## Product Improvement RMC-type Cables

Longitudinal embossed line  
180° opposite to the Slots

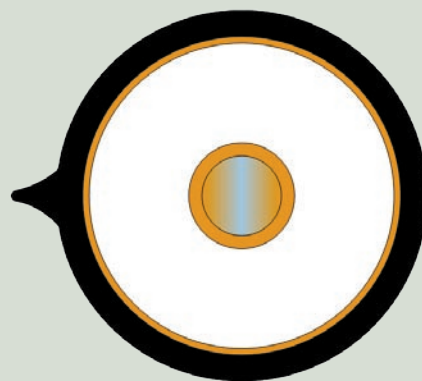
With immediate effect will all RMC-type Radiating Cables carry a longitudinal embossed line which is positioned 180° opposite to the Slots on the Outer Jacket.

This product improvement has been implemented to aide the correct positioning of the RMC-type cables even under restricted light conditions.

To ensure continued ease of Connector Installations, this longitudinal embossed line should be removed as part of the Cable preparation procedure.
